Grandstream Networks, Inc.

Request for Class II Permissive Change

FCC ID: **YZZHT70X** Data: January 3th, 2016

Original mainboard photo view

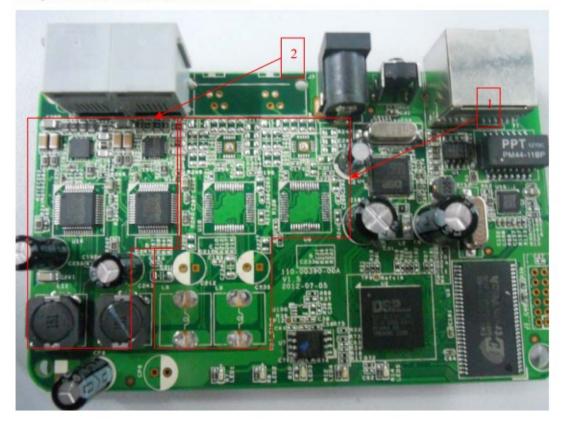
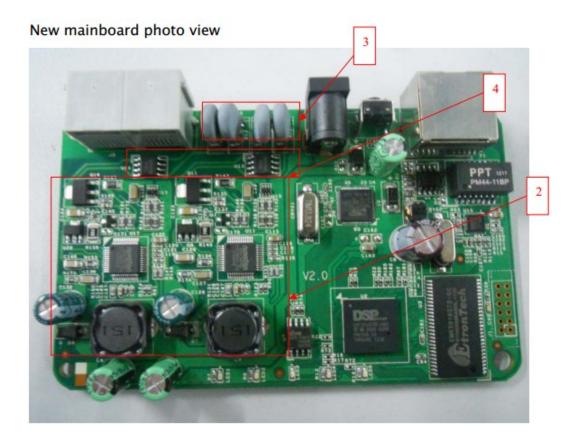
- 1. Deleted two Un-used SLIC Circuits (see Arrow 1) and replaced two integrated chips by discrete circuit (see Arrow2);
- 2. Add four 50 ohm PTCs (see Arrow 3) and two High Voltage protector ICs for TISP61089 (See Arrow 4)
- 3. Add two power adapter (Model: F06US1200050A/NBS05B120050VU) and has the same electrical specification with original power adapter
- 4. Changed brand of network transformer. Anything else are the same as before.
